AFFORDABLE HOUSING
DEVELOPMENT SSD-83256463
ARCHITECTURAL DRAWINGS
THE BOULEVARDE
PUNCHBOWL
COLLINS AND TURNER
SEPTEMBER 2025

No	Date	By	Note
B	9/12/2025	DC	For RTS

Project	
Affordable Housing Development SSD-83256463 150 The Boulevard and 34 Dudley Street Punchbowl, NSW

3 Ground Floor
1:50

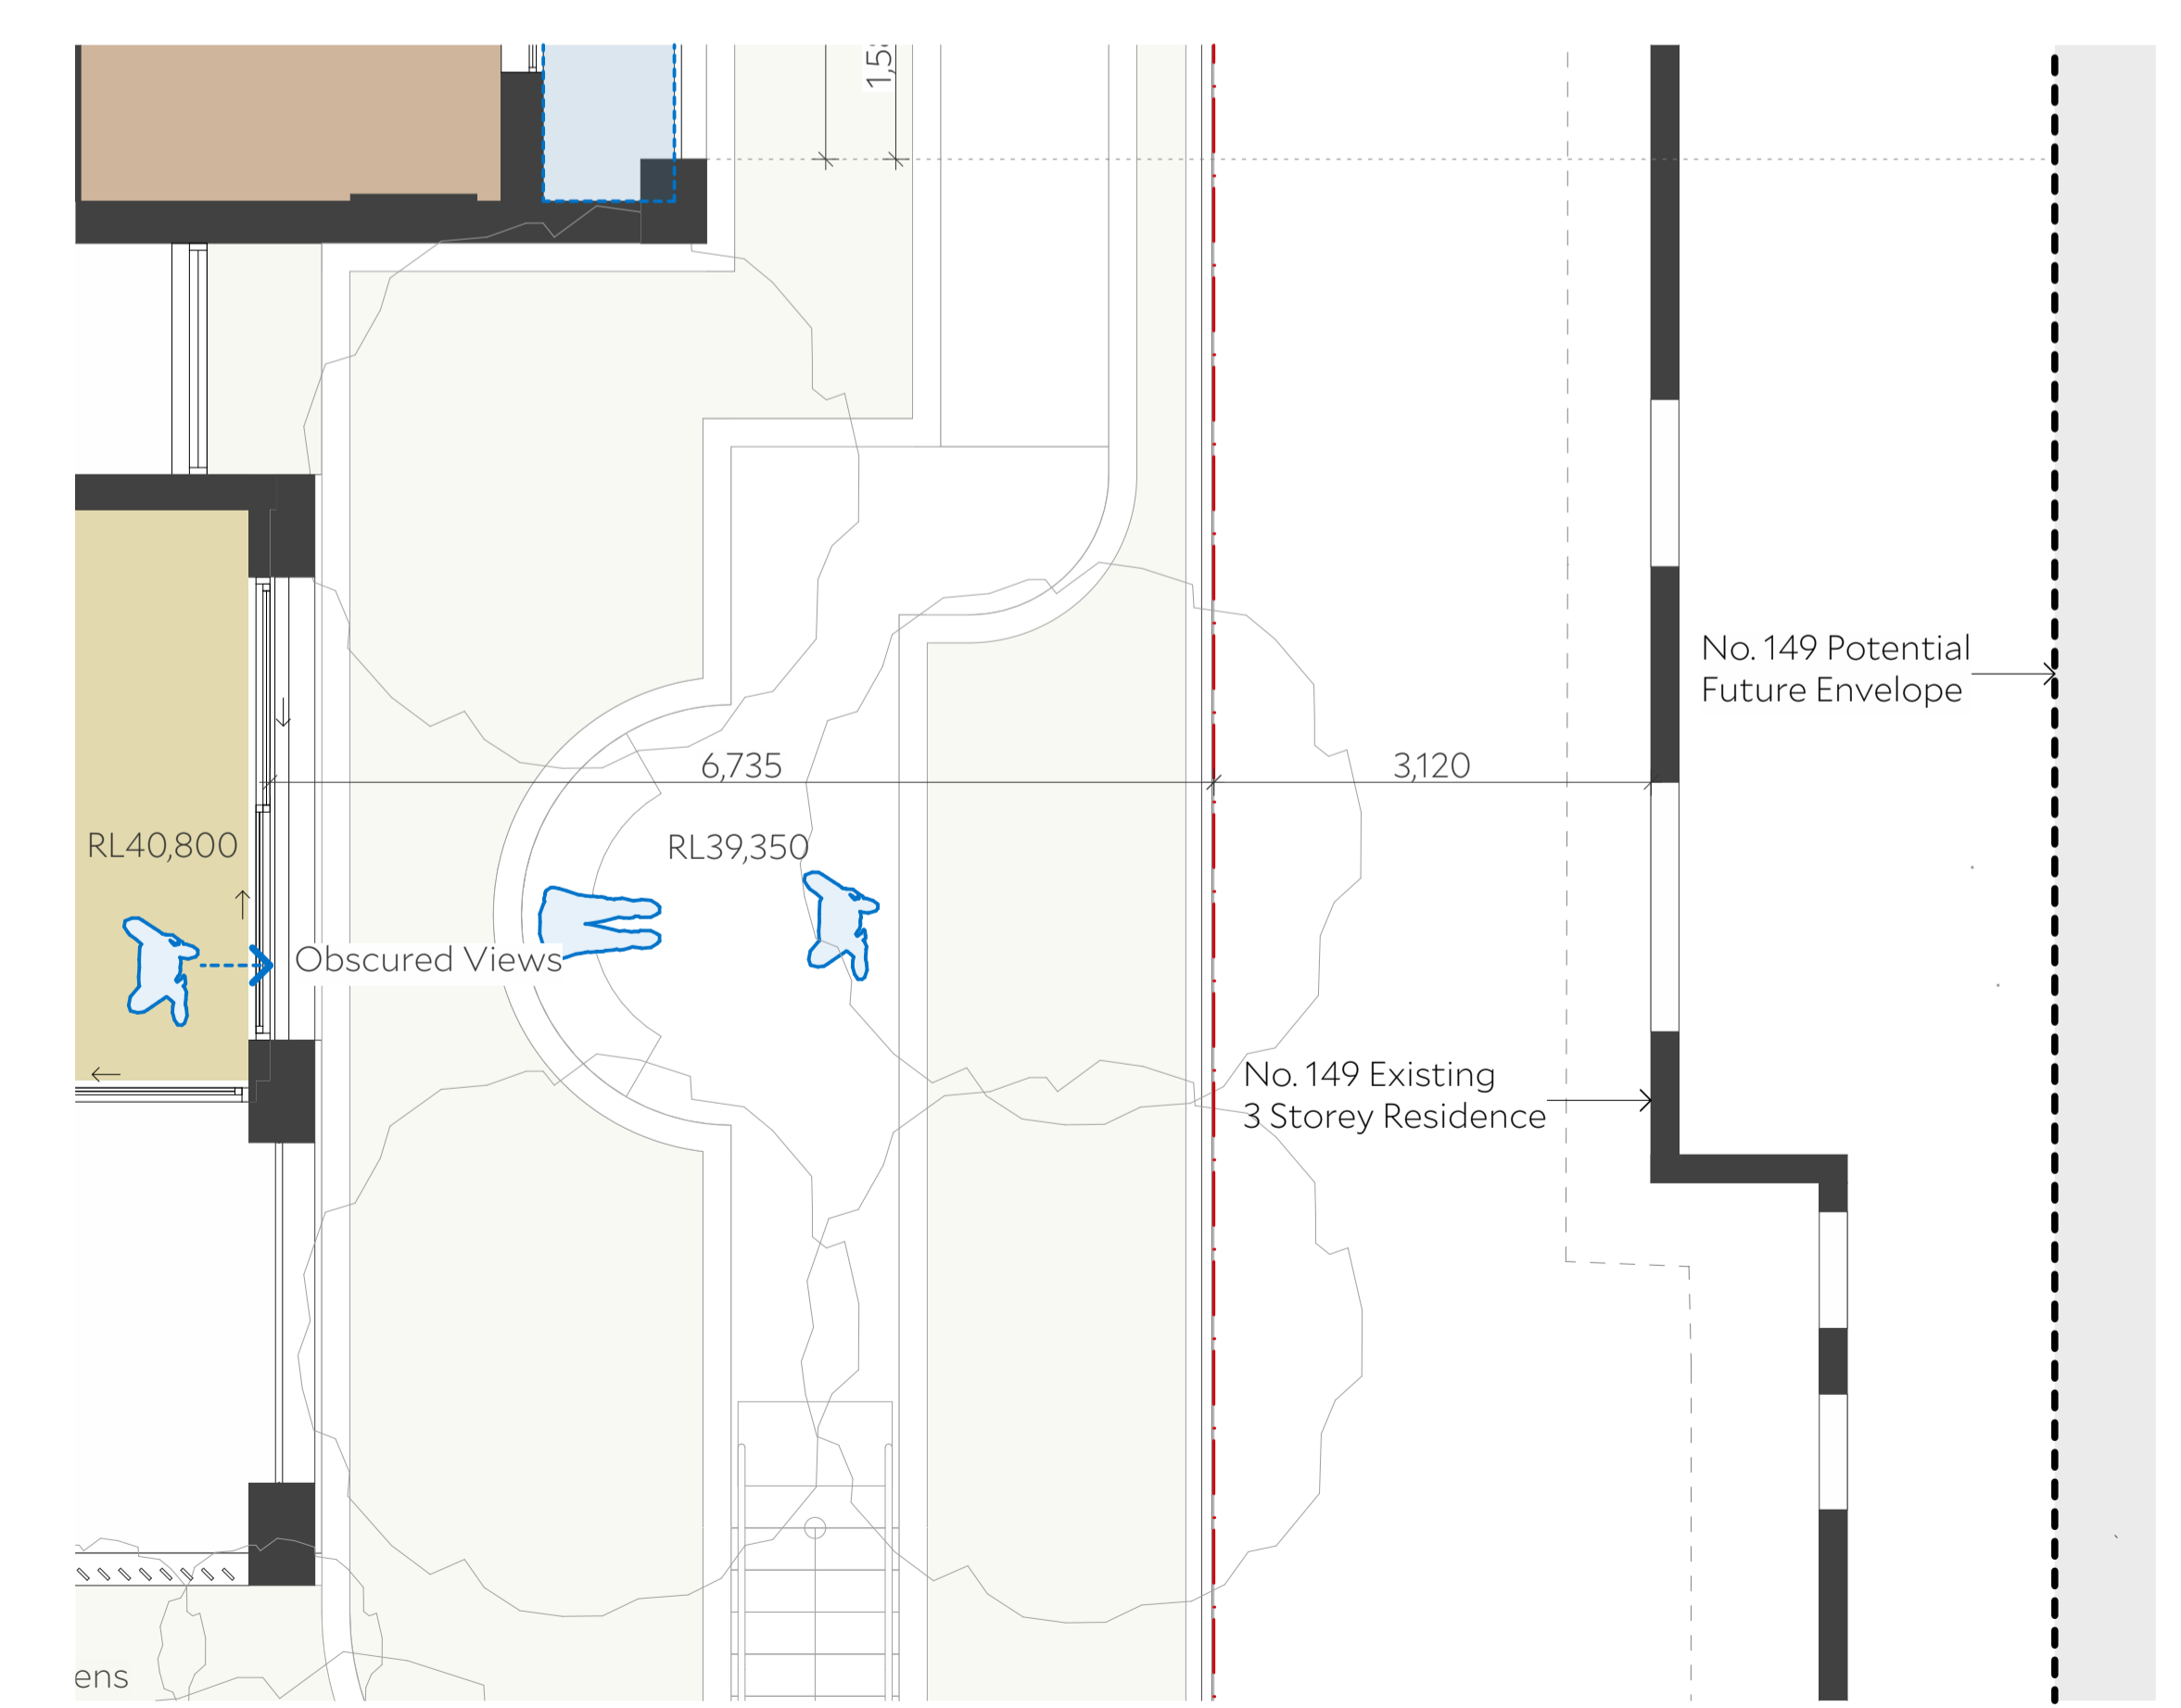
ID	Name
14	Horizontal privacy screens added Refer to RTS Item CB-UD2.1
